**Document ID:** IK1200969

**Title:** 2010+ IBB ETV (Engine Throttle Valve) - Diagnostics

**Applies To:** 2010 - Current Maxxforce 11/13 & N13 Engines

**Figure 1: Cylinder Head Intake Manifold**

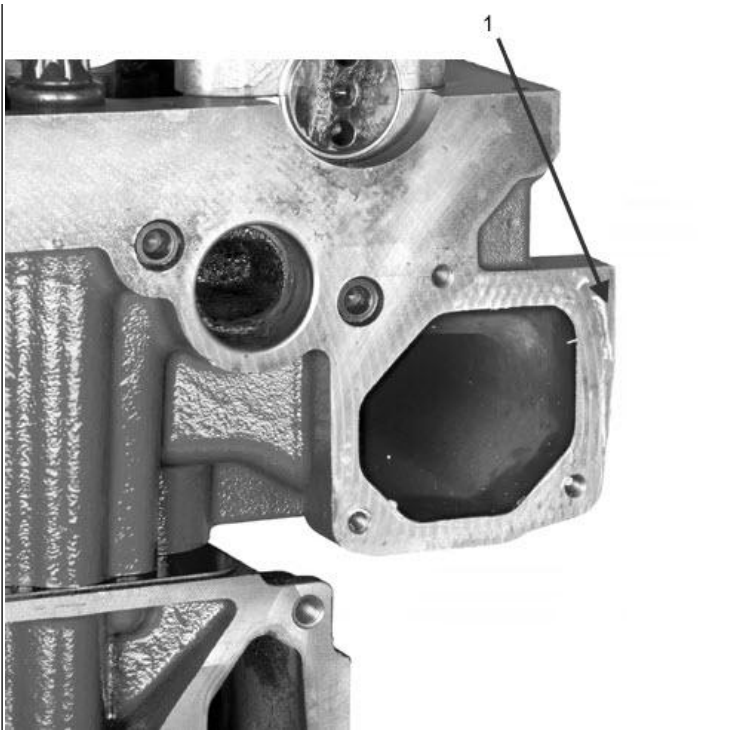
The "old" seal between the Engine throttle duct and cylinder head is RTV; that is, Wacker 442, Loctite® 5900 Sealant, or equivalent. This should no longer be used, and the Intake Throttle Gasket noted above, should be used instead.

Use a scraper to remove the RTV application on the cylinder head and engine throttle valve (if not done already), and install the engine throttle valve gasket with the air intake throttle duct.
